UNITED STATES PATENT AND TRADEMARK OFFICE

APPLICATION NO.	FILING DATE	FIRST NAMED INVENTOR	ATTORNEY DOCKET NO.	CONFIRMATION NO.
10/730,440	12/08/2003	Chandra Sekhar Namuduri	GP-303152	2250

Office Action Summary

DETAILED ACTION

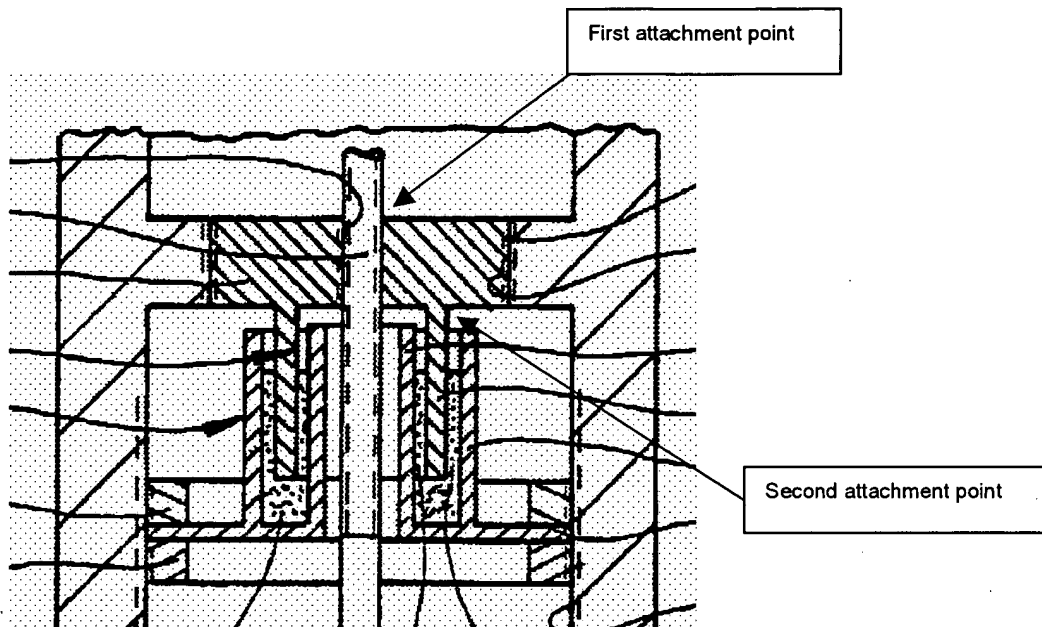
Re: claims 1, 2, 7, and 12. Weyand shows in figure 2 a damping apparatus comprising: a linear to rotary conversion mechanism comprising a translatable member 34 having a first attachment point as shown in the labeled version of figure 2 of Weyand shown on the following page that is adapted for generally linear translation in a forward and a reverse direction and a rotatable member 34 comprising a rotatable shaft that is

rotatably coupled to the translatable member; wherein translation of the translatable member in one of the forward or the reverse directions produces a forward or a reverse rotation of the rotatable member and shaft, respectively, and a damping mechanism comprising a second attachment point as shown in the labeled version of figure 2 of Weyand, a hub 32 that is fixed to the shaft.

Examiner notes that Weyand clearly shows first and second attachment points in the labeled version of figure 2 of Weyand, as broadly recited.
